WARRANTY BULLETIN

WB18-01A

DATE :	January 2018	SECTION :	18 BODY
EXPIRATION:	January 2020		
SUBJECT :	PARCEL RACK DOORS REINFORCEMENT

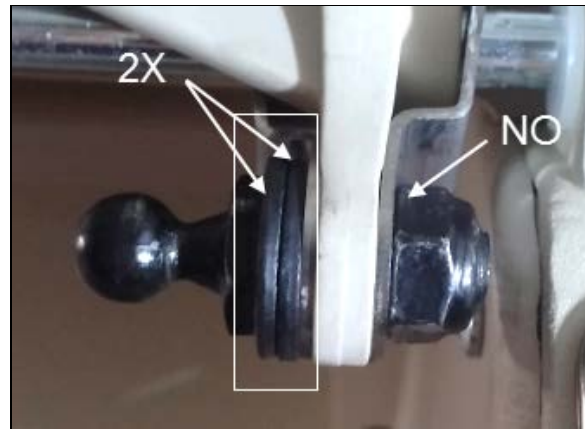
6. Insert the exterior (larger) reinforcing plate and slide back the pivot rod in place (center the rod 50% on each side).

7. Lock the pivot rod in place.

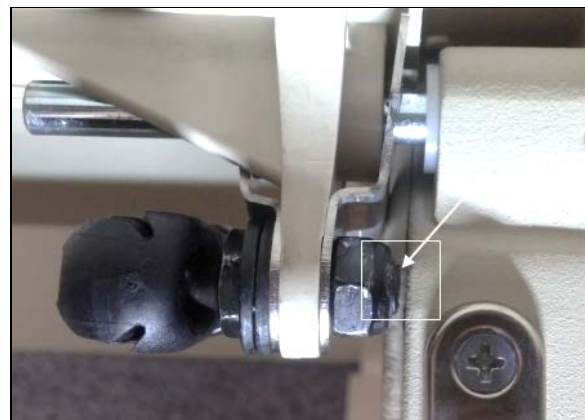
8. Insert the interior (small) reinforcing plate.

9. Reinstall the ball stud. Discard the washer on the nut side - Install both washers on the ball side.

TORQUE BALL STUD TO 30 LB-IN

10. Put back the gas shock into position; make sure the locking clip locks the shock in position.
